# DEVIATION REQUEST AND DECISION FORM

Project Name : Grandview Reserve Phase 1

A deviation from the standards of or in Section 2.2.5.C (and 2.3.2) of the *Engineering Criteria Manual (ECM)* is requested. The request is for a full-movement intersection on the proposed Rex Road 575 feet east of Eastonville Road (centerline spacing). The proposed plan for Grandview Reserve Phase 1 is to extend a public street south from Rex Road at this location to serve as one of the access points to this relatively large development. Given this proposed spacing, the intent would be that this intersection would be a T intersection with a street on the south side only. Please refer to the attached exhibits. Also, please refer to the TIS report prepared for this project for additional information.

Exhibit 1

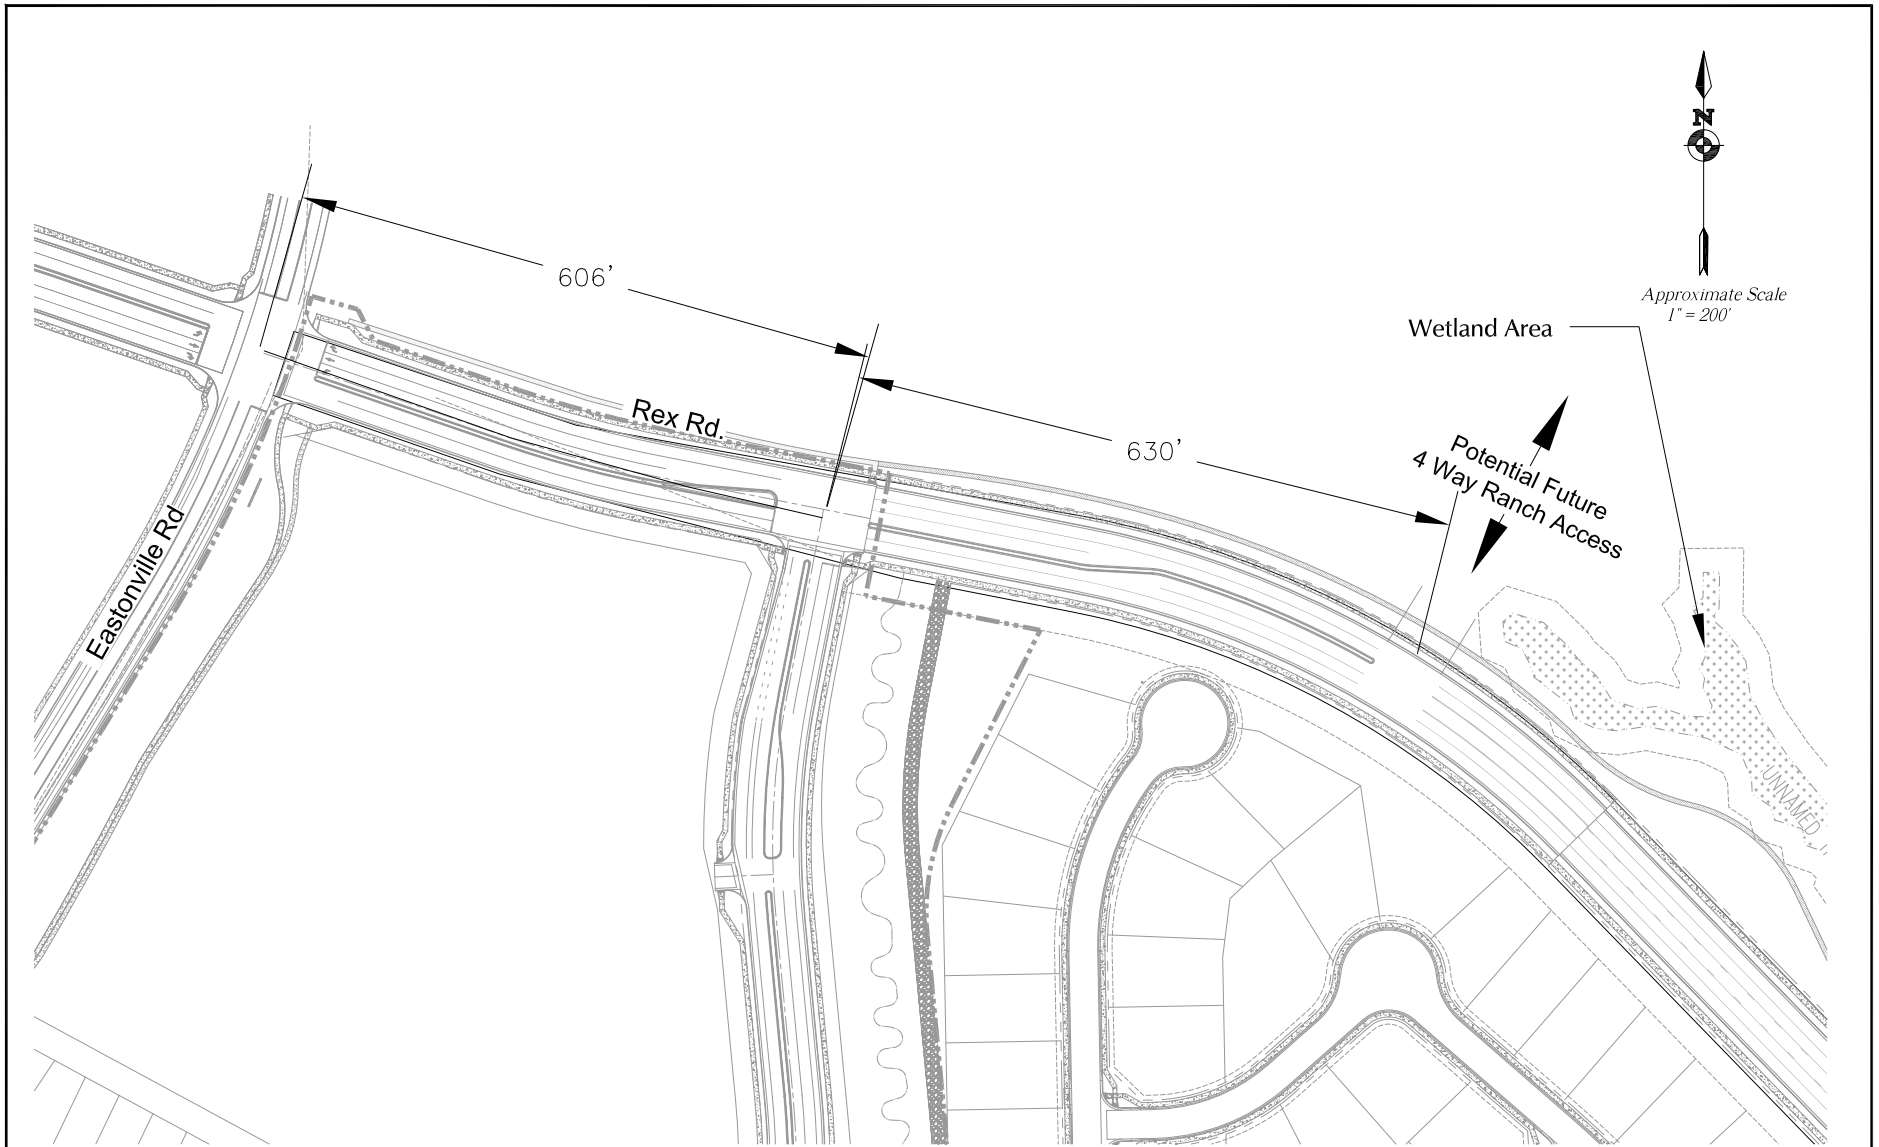
\*Spacing will need to be greater than 700' (700' will not be sufficient); exact spacing to be determined with development of the commercial parcels.  
 \*\*Spacing dependent on the "to be determined" spacing of the adjacent segment (shown as >700').
